Work Description: Site Public Space approval

Re: Review of Drawings for Murch Elementary School

References to drawing numbers refer to the drawings prepared by CDDI titled “Murch Elementary School Addition and Modernization” dated 9/30/2016 with no revisions noted.

EXISTING SURVEY DRAWINGS

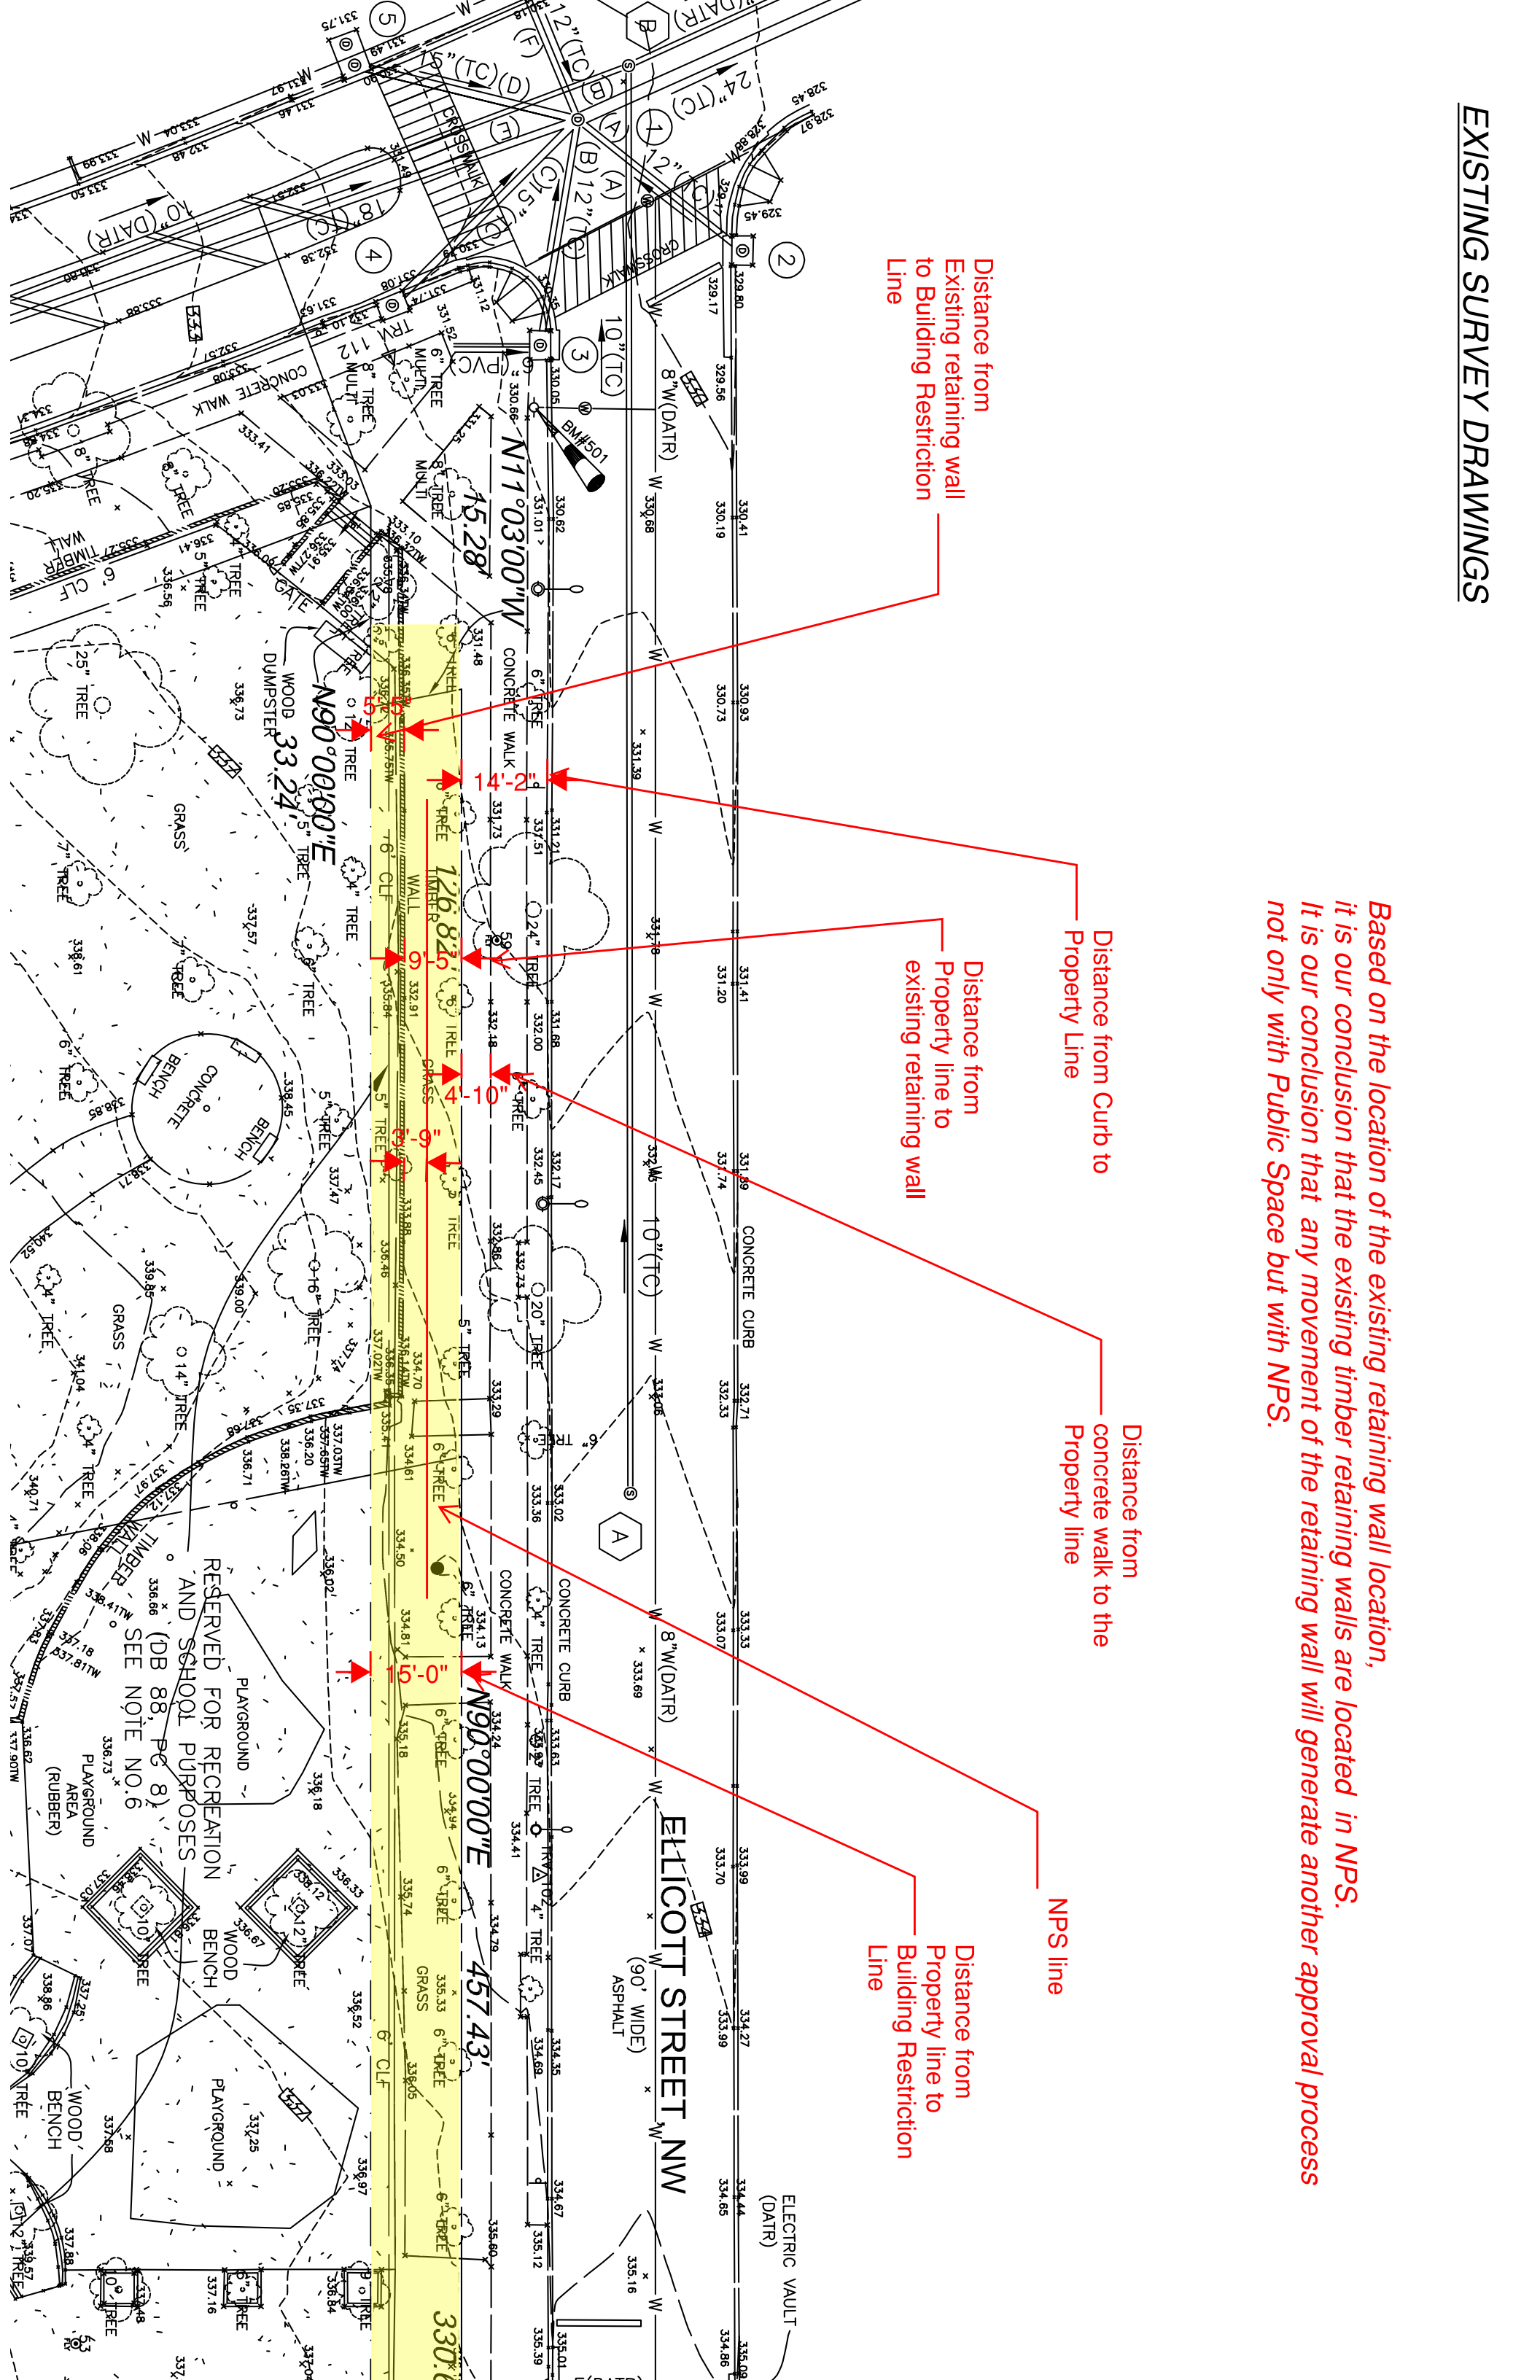
Based on the location of the existing retaining wall location, it is our conclusion that the existing timber retaining walls are located in NPS. It is our conclusion that any movement of the retaining wall will generate another approval process not only with Public Space but with NPS.
